Re: Response to El Paso County Review Comments  
Redtail Ranch Subdivision  
Sanctuary Pines Dr  
Parcel No's: 5209002006, 5209002008, 5209000129 and 5209000128  
El Paso County, Colorado

RMG – Rocky Mountain Group (RMG) prepared a Geology and Soils report (RMG Job No. 162652, last dated March 4, 2019) for the proposed residential development project comprising 12 single-family residential lots located at the parcel no.'s referenced above. The report was reviewed by personnel of the El Paso County Planning & Community Development in September 2018 and again in February 2019. The majority of the original comments were addressed in the revised Geology and Soils Report.

Per the February 2019 redlines on the last dated January 18, 2019 RMG report, additional comments to be addressed are as follows and for clarity and ease of review we have reiterated each of the EPC Comments followed by our response.

## **GEOLOGY AND SOILS REPORT and Wastewater Study with Detention Storage Criteria**

CONCEPT  
PLAN

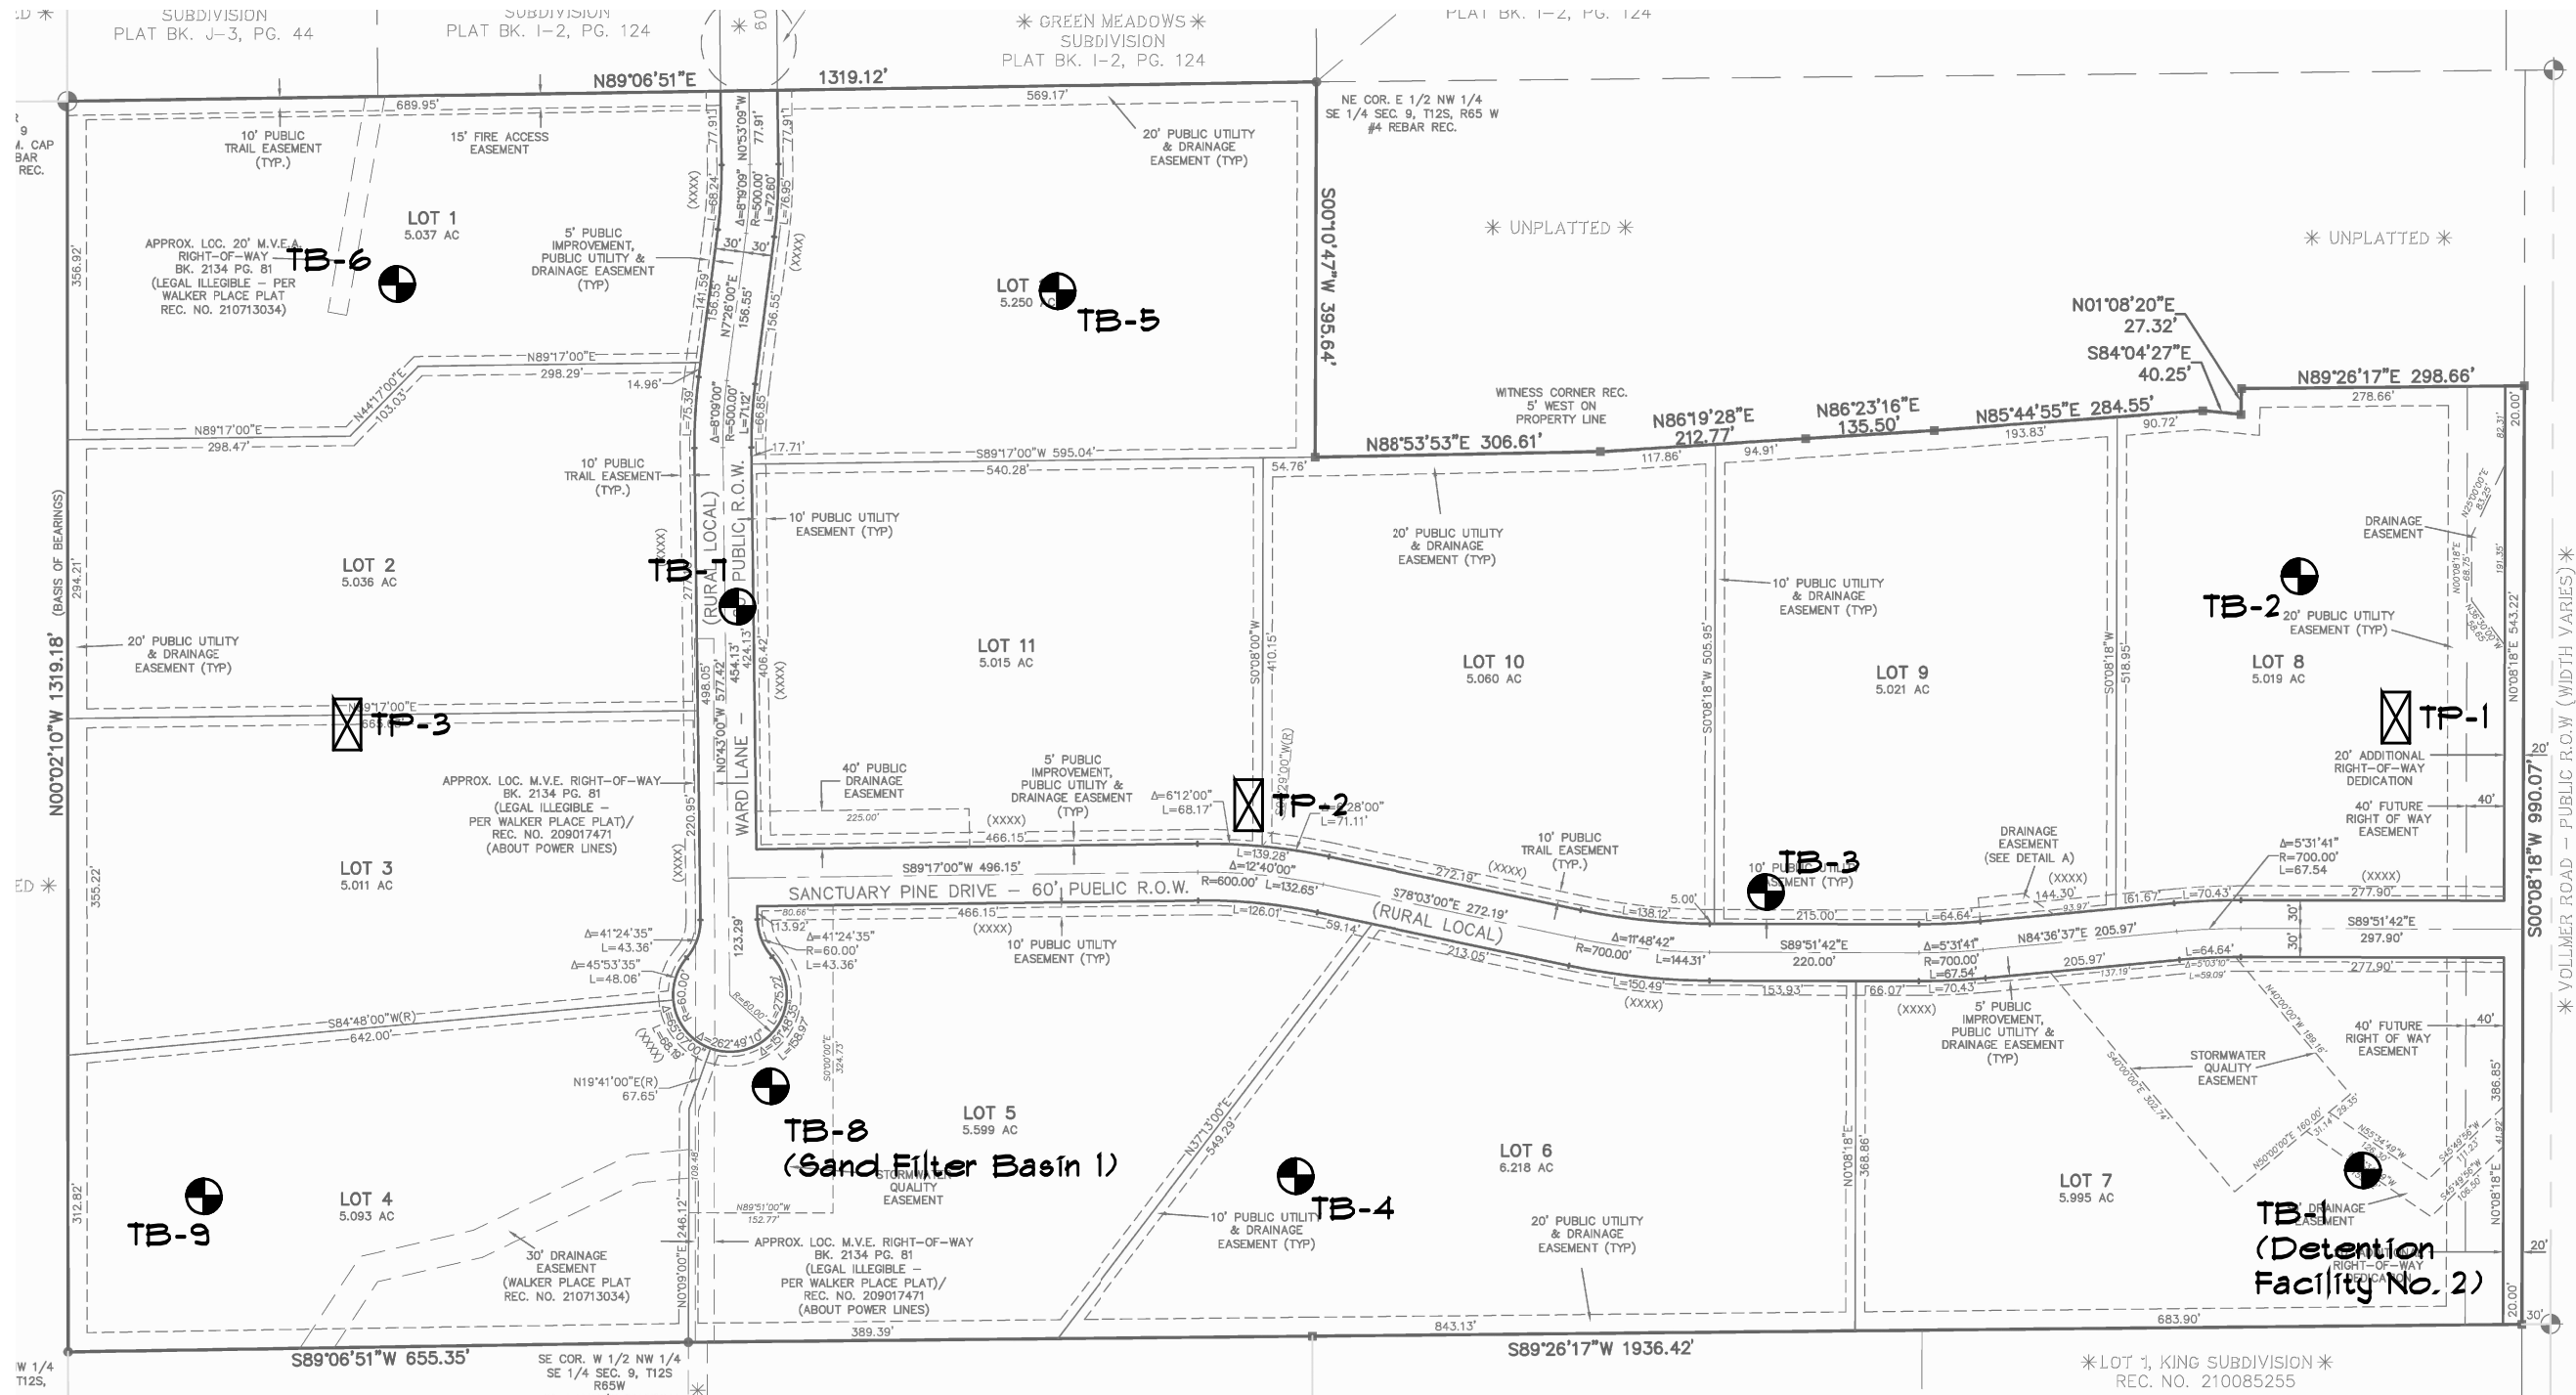
- **EPC County Comment:** *"Existing pond to remain and obtain "Exempt Stock Tank" permit?" as denoted on RMG's Figure 3, Concept Plan and Figure 4, Concept Plan with Test Boring and Test Pit Location Plan.*

RMG Response: It is RMG's understanding that the pond is to be filled in on Lot 3, as noted on the revised Figure 18, General Geology and Engineering Map.
